has permission to Single Family Home - 1 Story - bedroom / 2 car garage

City of Portland, Maine - Building or Use Permit Application

Permit No: 08-0798	Issue Date: AUG 18 2008	CEL: 439 B010001
-----------------------	----------------------------	---------------------

ONE AND TWO FAMILY	PLAN REVIEW	CHECKLIST
Soil type/Presumptive Load Value (Table R401.4.1)		
Component	Submitted Plan	Findings Revisions Date
STRUCTURAL Footing Dimensions/Depth (Table R403.1 & R403.1(1), (Section R403.1 & R403.1.4.1)	12" x 24" Footing - 8" Wall - 8' below	
Foundation Drainage, Fabric, Damp proofing (Section R405 & R406)	Shows 4" drain w/ sock & foundation coating	
Ventilation/Access (Section R408.1 & R408.3) Crawls Space ONLY	N/A	
Anchor Bolts/Straps, spacing (Section R403.1.6)	1/2" diam bolts - 6' - OC	
Lally Column Type (Section R407)	4- 2" x 12" - S	
Girder & Header Spans (Table R 502.5(2))	OK - 11'-9" Max span	
Built-Up Wood Center Girder Dimension/Type	" "	
Sill/Band Joist Type & Dimensions	2" x 6" PT Plate	
First Floor Joist Species Dimensions and Spacing (Table R502.3.1(1) & Table R502.3.1(2))	Floor Trusses	Want truss design prior to issuance - 38' clear span roof truss - bearing points? wan

FLAHERTY RESIDENCE
 FLOOR PLANS & FOUNDATION

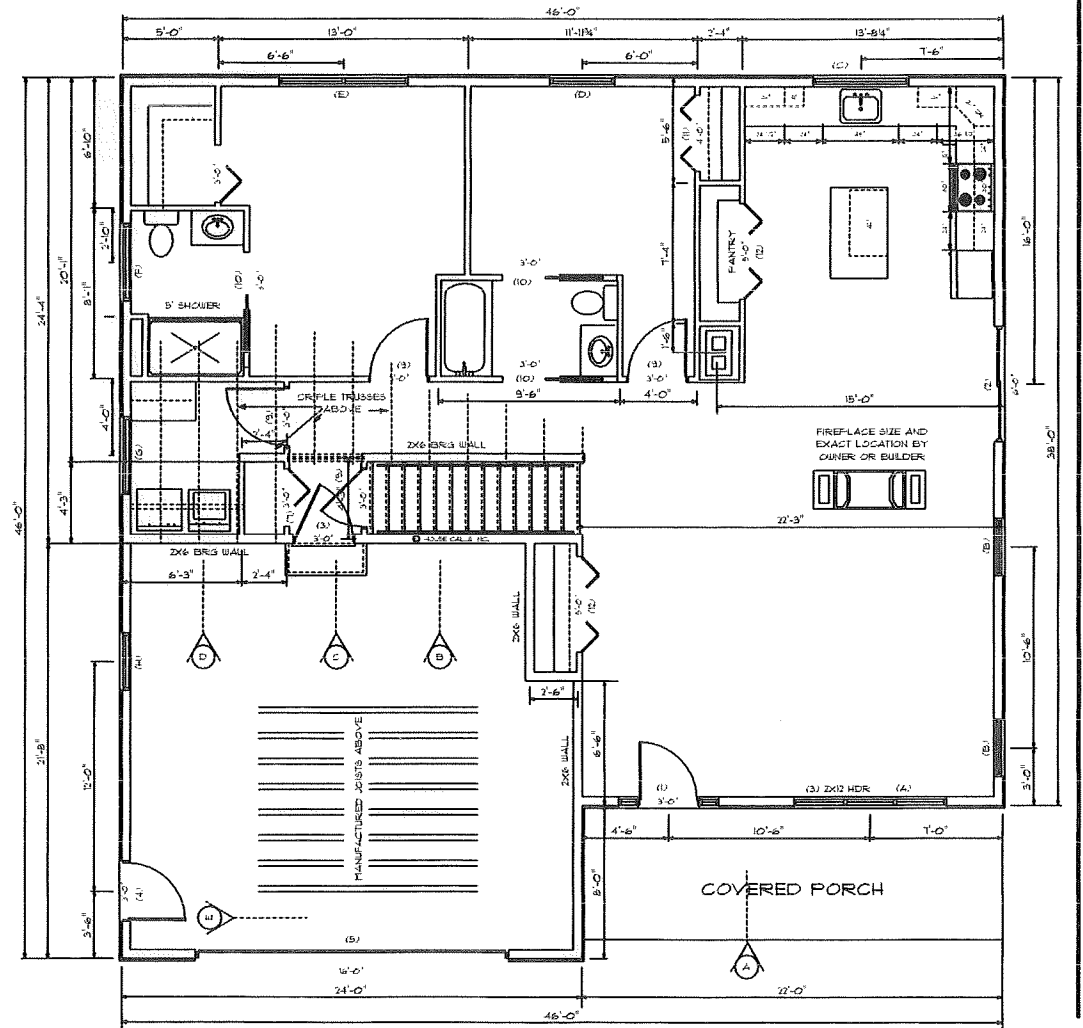
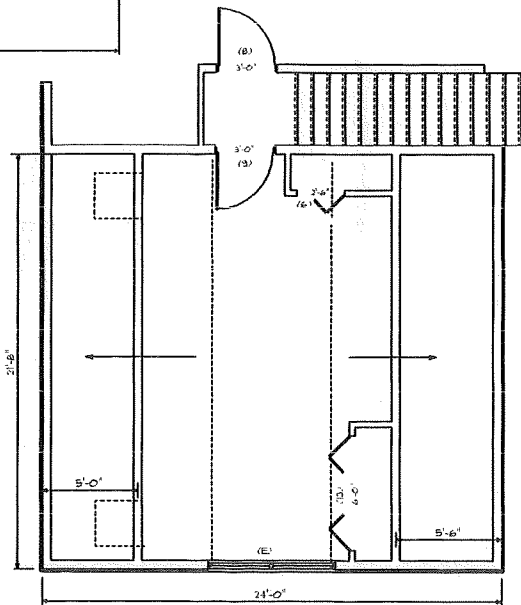
(17) Fire separation (Section R309.2) - <i>not noted</i>		
Opening Protection (Section R309.1) <i>OK - shows fire door</i>		
Emergency Escape and Rescue Openings (Section R310)	OK	
Roof Covering (Chapter 9)	Asphalt	
Safety Glazing (Section R308)	N/A	
Attic Access (Section R807)	N/A

Need to insulate bsmt / 1st floor - or rigid Ins.
- U-Values of windows

① Type of Heating System	not shown - Gas fired furnace	
② Means of Egress (Sec R311 & R312) Basement Number of Stairways 1 Interior 1 Exterior 2 Treads and Risers $T = 10''$ Min (Section R311.5.3) $R = 7\frac{3}{4}''$ Max Width (Section R311.5.1) 36'' ③ Headroom (Section R311.5.2) not shown - 6'-8" OK Guardrails and Handrails (Section R312 & R311.5.6 - R311.5.6.3) OK - front rail not req - not over 30"		
④ Smoke Detectors (Section R313) Location and type/Interconnected	Condition	
Draftstopping (Section R502.12) and Fireblocking (Section R602.8) Dwelling Unit Separation (Section R317) and IBC - 2003 (Section 1207)	N/A	
Deck Construction (Section R502.2.1)	N/A
